Application - CA/23/00484

Location - Land At The Hill, Bekesbourne Lane, East Of Bekesbourne Hill, Bekesbourne, Canterbury, CT4 5EA

Proposal - Outline planning application for up to 300 residential dwellings (including affordable housing and older person accommodation), a new community hub, introduction of structural planting and landscaping, informal public open space and children's play area and surface water flood mitigation and attenuation. All matters reserved except for access.

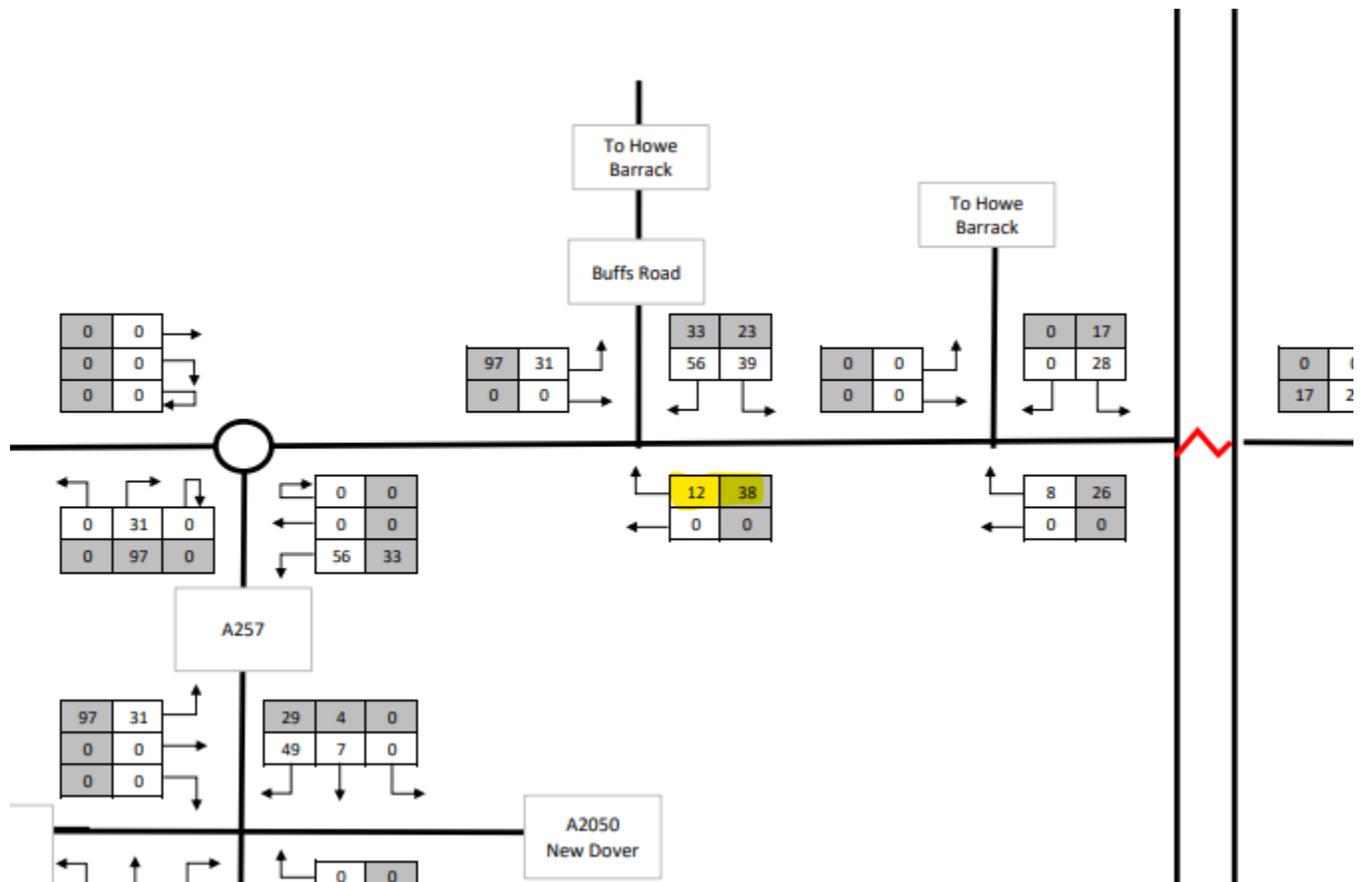
Having assessed the submitted traffic survey data, I concur that the traffic flows recorded via the ATC placed on The Hill validate the one day manual turning count figures that have been used.

As such we are minded to accept the manual turning count figures as surveyed.
